Agenda Item 4
744 Northmoor Road
Alterations and Second Story Addition

Consideration of a request for approval of a second story addition for living space over an attached garage.

Agenda Item 5
821 Northmoor Road
Continued - Revisions to Previously Approved Plans
Building Scale Variance and Height Variance

Continued consideration of a request for a recommendation in support of mid-project revisions to previously approved plans for additions and alterations to the residence at 821 Northmoor Road. A building scale variance is requested.

47" / 120 cm – Warm White

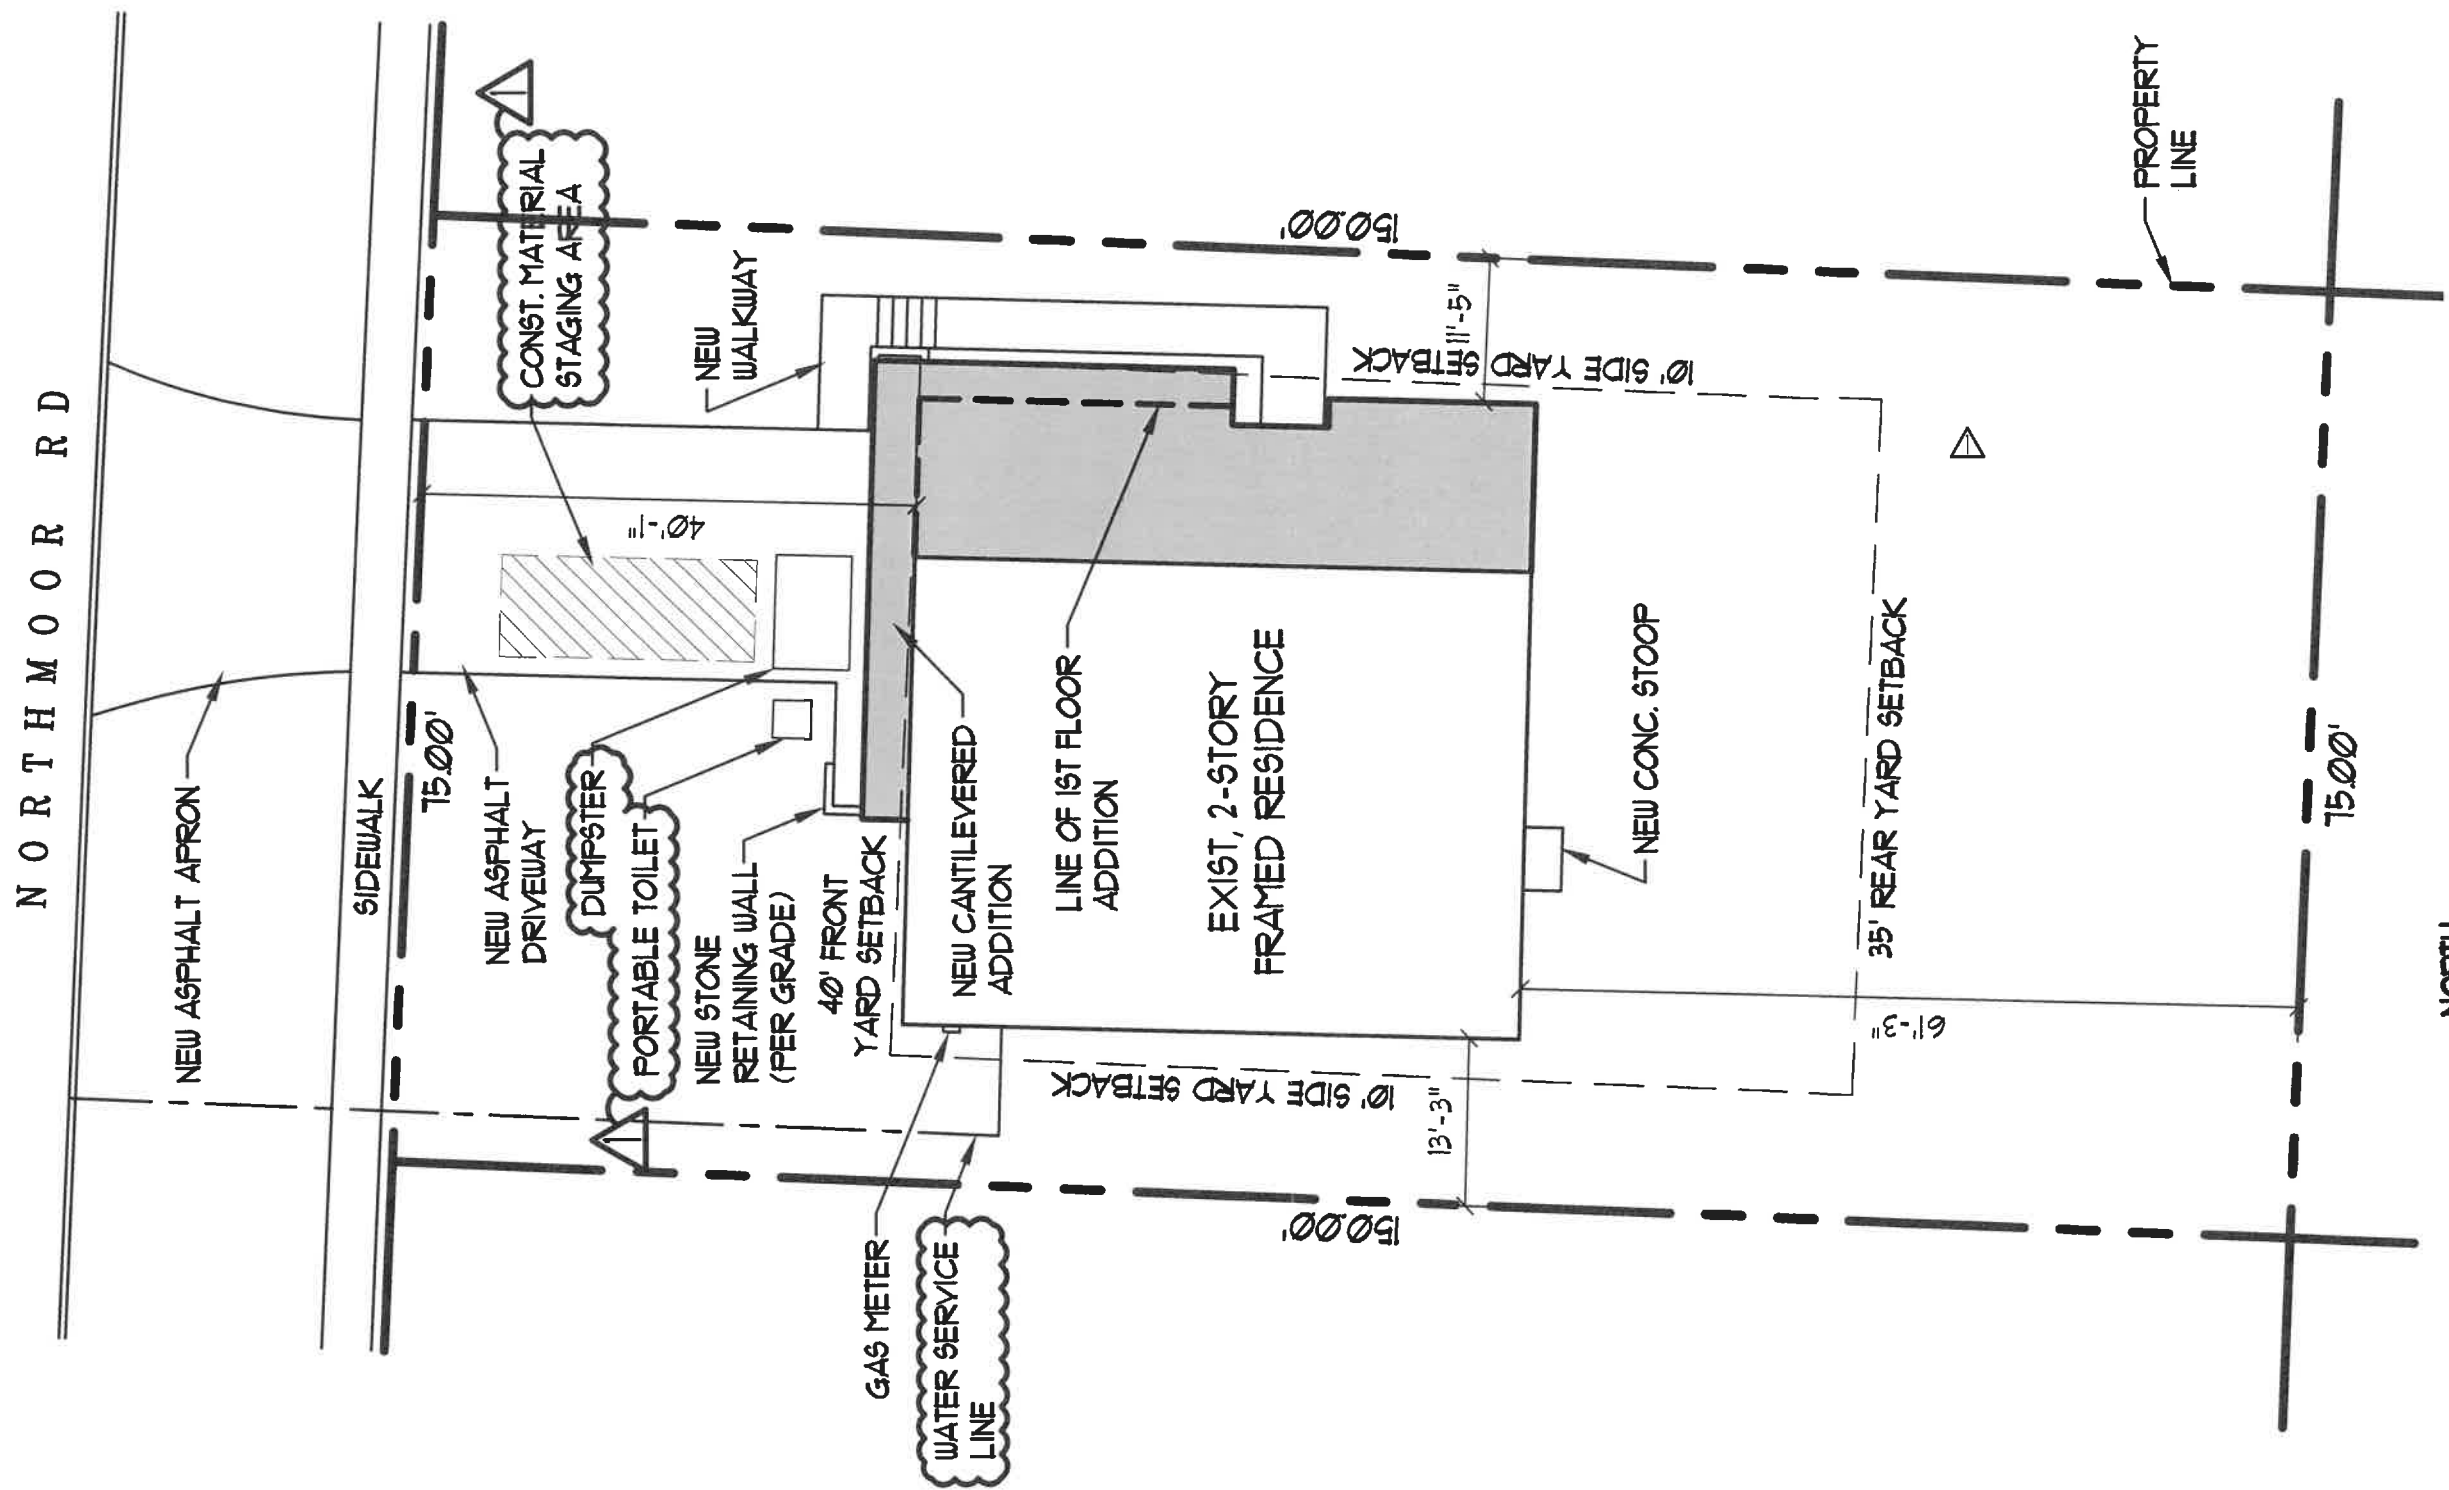
A lighting fixture cut sheet was provided by the petitioner and is included in the Board packet. No information on the proposed location of the

lighting was provided however, the style of the fixture is not consistent with the Residential Lighting Guidelines, the fixture neither shields the light source nor directs it downward.

Recommendation: Direct further study of exterior lighting fixtures and submittal of an exterior lighting plan and cut sheets of fixtures that comply with the City's Lighting Guidelines.
